**ISSUE:** Certificate of Appropriateness for alterations

**APPLICANT:** Harbor Terrace of Old Town Condominium Unit Owners Associations.

551 Bashford Lane

## STAFF RECOMMENDATION

Figure 1: Site plan with cooling tower circled. PRGS to upper right.

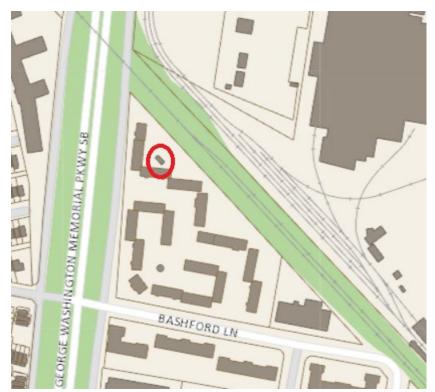
The development is bounded by East Abingdon Drive to the west, Bashford Lane to the south, a car service facility to the east, and railroad tracks and public parkland to the northeast, creating a quasi-triangular lot. The proposed cooling tower will be visible from the railroad tracks and parkland to the northeast but will not be visible from any roadways, including the George Washington Memorial Parkway. See Figure 1 for site plan.
